From: Werner, Jeffrey B
Sent: Wednesday, October 19, 2022 4:07 PM
To: jd@bdarchitects.com
Cc: Jeffrey Levien; Whitney Hudson
Subject: 612 West Main - BAR Action Oct 18, 2022

BAR # 22-10-03

612 West Main Street (also 602-616), TMP 290003000

Project: New building: modification to approved façade

NORTH ELEVATION
BAR SUBMISSION MEETING:
12.21.2021

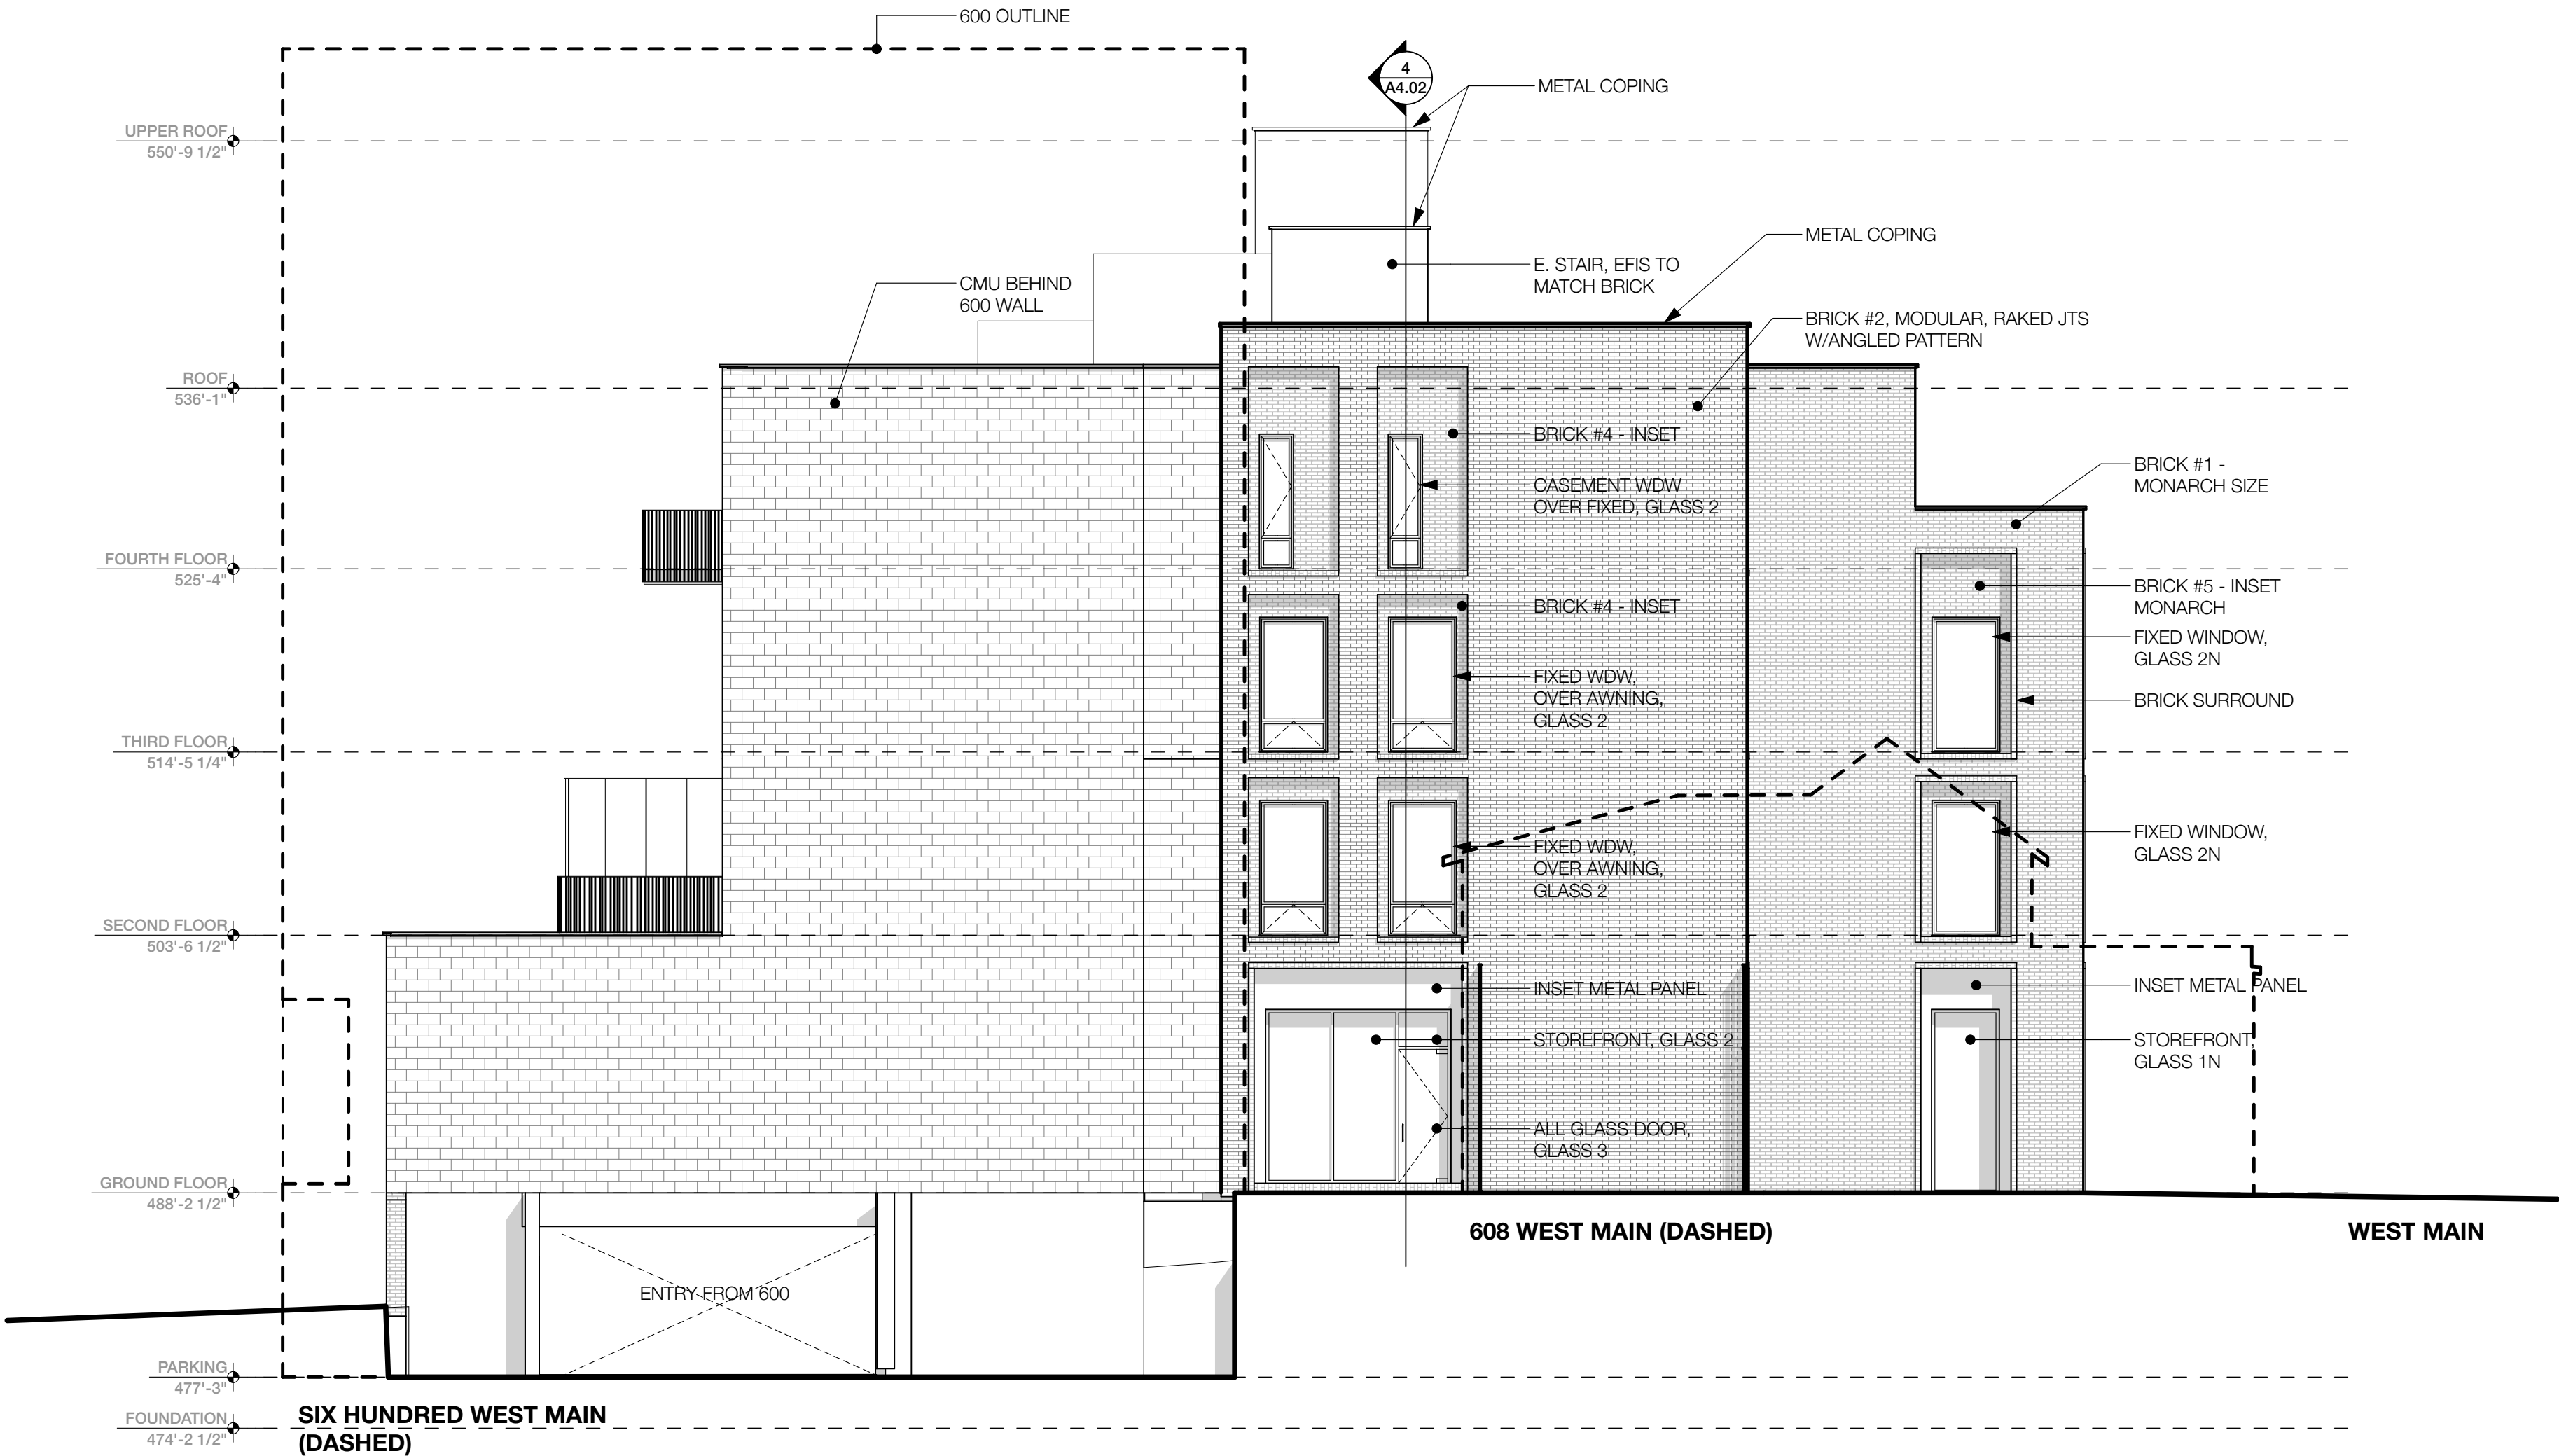
Mr. Lahendro – I would like to talk about the North elevation. This looks better to me than what I'm hearing than what's actually meant. The recessed planes of the hyphens are darker and obviously more recessed. The darkness is a symbol to indicate some kind of texture. What I'm hearing is that the texture that's desired at this point is subtle and not distinctive. I would prefer to see something that's more distinctive in the difference. I think this reads as we had intended or we had stated all along in that we're trying to mimic the scale of the individual historic buildings that are still left on this part of West Main that were here originally. That's my biggest worry about this elevation.

Mr. Gastinger – I am a little concerned about the subtlety and the thinness of the plane of the North elevation. It's not so much the elevation but more that the plan and the perspective views that would come from it. I'm concerned because I think almost every view from a pedestrian point of view or for driving down the road that this is really going to look like a long building because the plan changes are so subtle. As mentioned in the last meeting, the addition of those balcony railings stepping that height down the introduction of some different texture are some good techniques. It's really riding on that line of whether this is meeting that SUP recommendation that the mass is breaking down. It might be useful to include some more oblique perspectives in the package in the future. I think that's how this building will most likely be seen. If the intention is to truly have the brick in the textured brick berry so similar in color, I wonder if a more radical technique like making one of the bays that textured brick might be worth considering. I just continue to look for more depth from the façade. I am just worried that it's getting keeps getting thinner and thinner.

MATERIALS

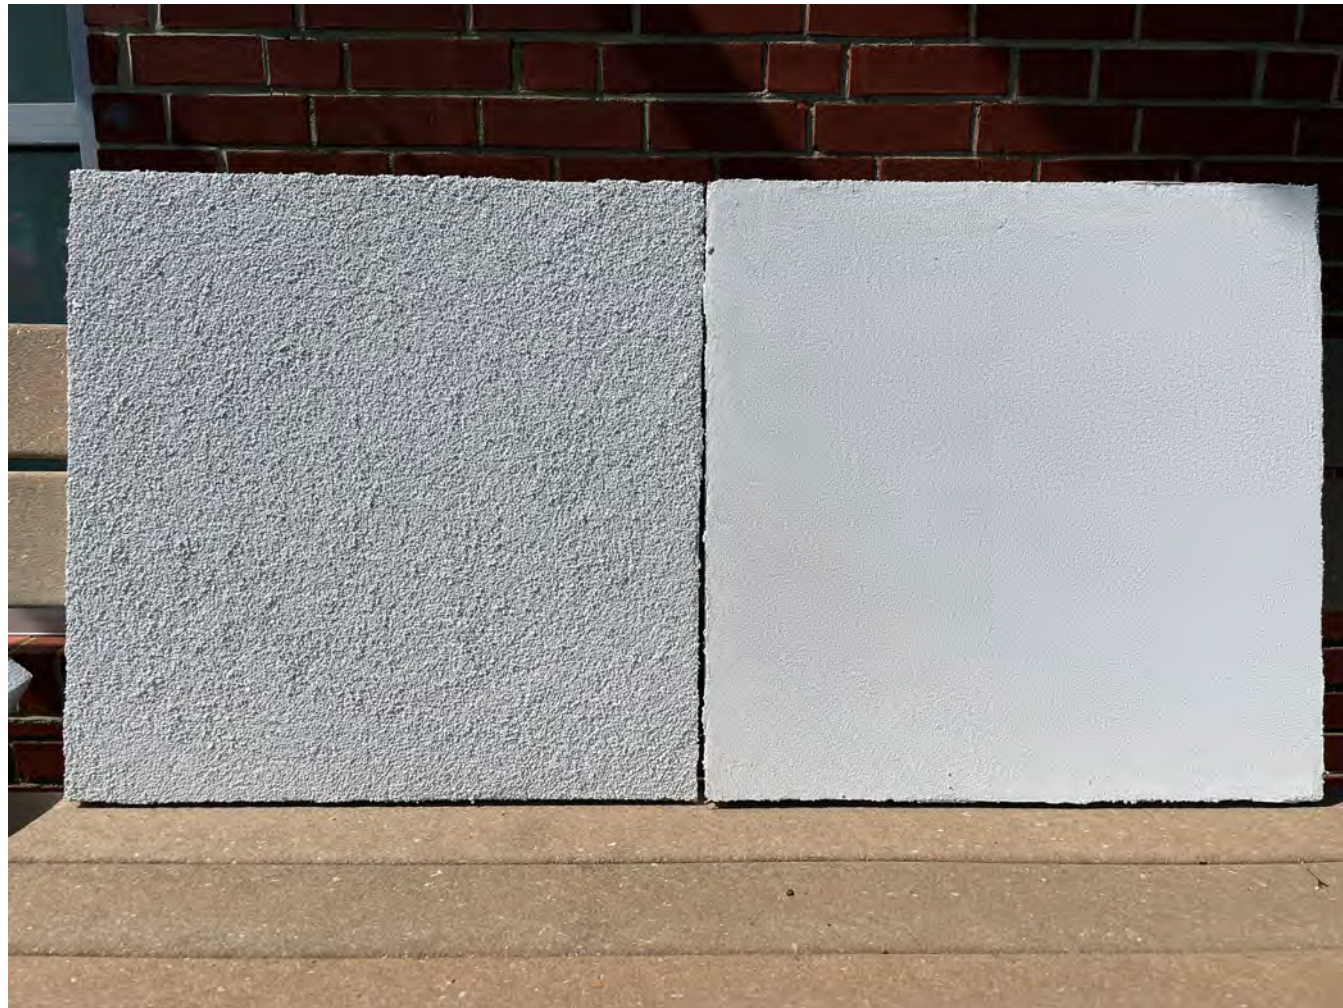
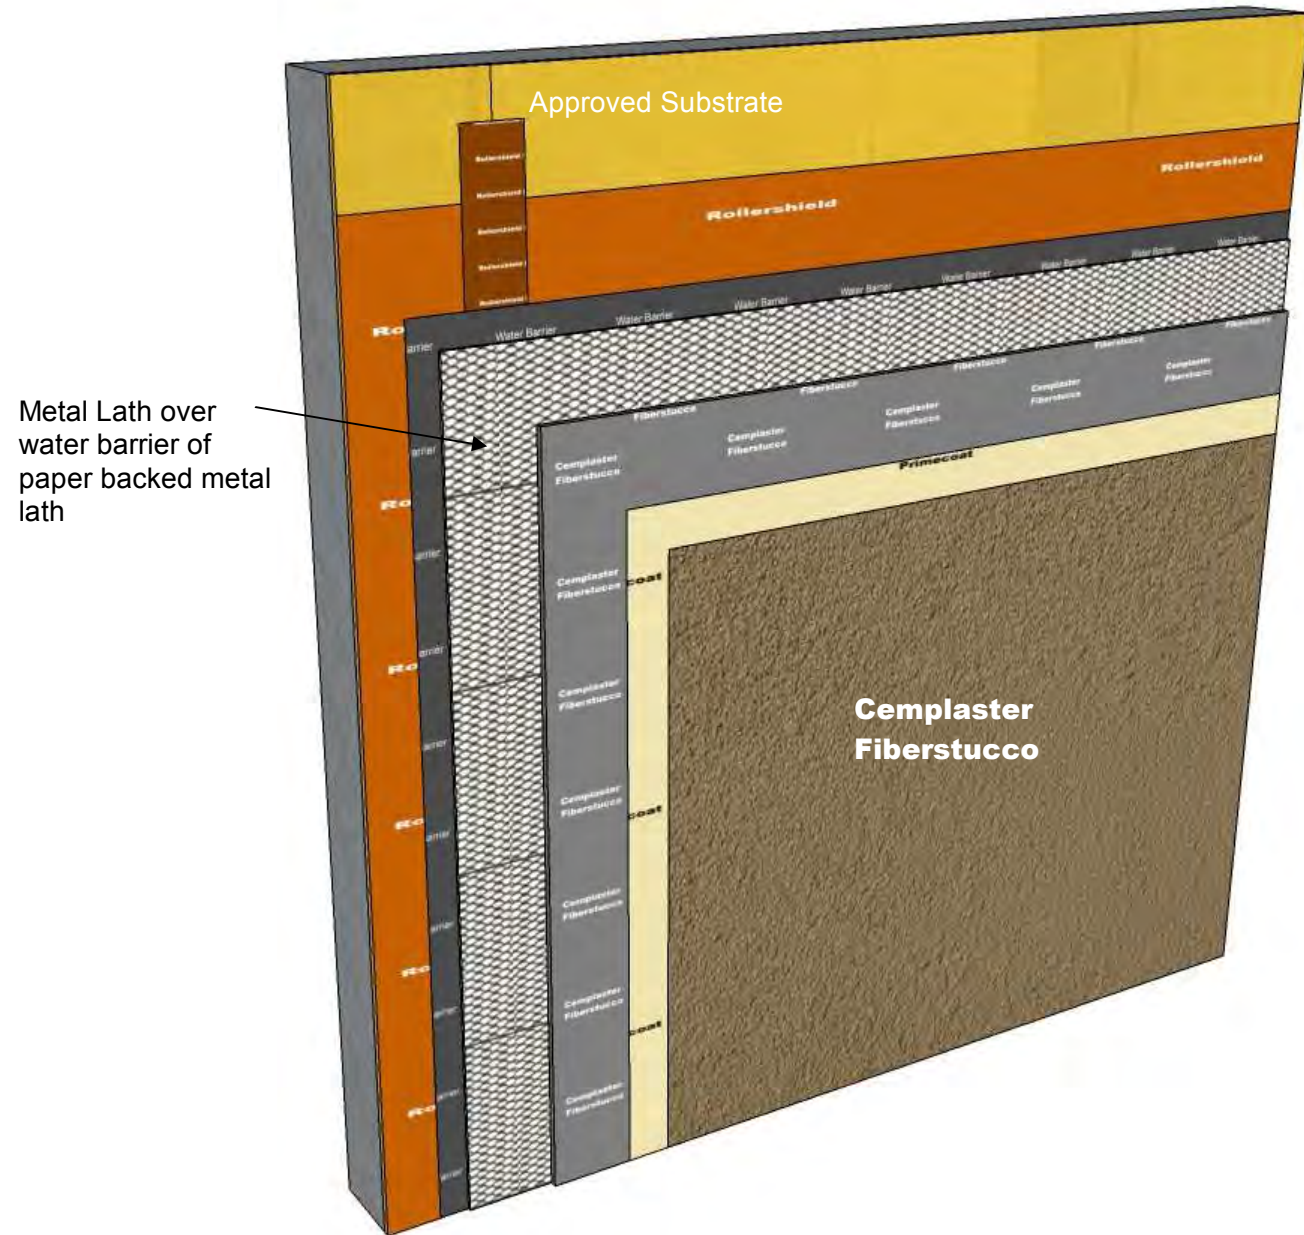
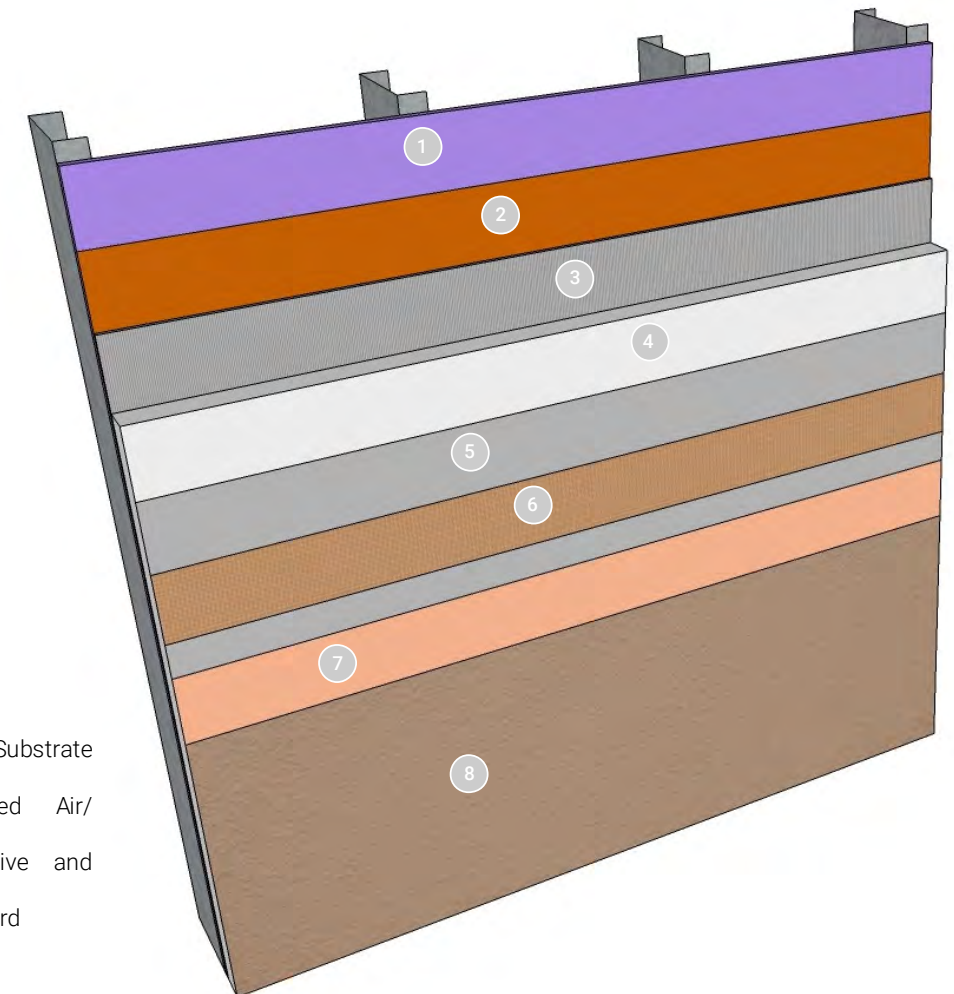
- that the BAR see a sample panel mock-up of the EIFS and stucco materials to confirm its color, texture, and that there will be sufficient differentiation between the various portions of the building and we suggest the mock-up be built with a north orientation.

Mr. Schwarz – I am going to add on the subject of materials that although I would love to see an unpainted light colored brick, painted brick would be far superior to stucco just because of stucco means EIFS. I would want to see something hard and durable on the ground floor. I don't know if there is another masonry products that you could look at.

Mr. Schwarz – Are we all OK with the change to stucco/EIFS at the back? Are we all still on board with the massing? There seems to be more desire for more originality in the front façade.
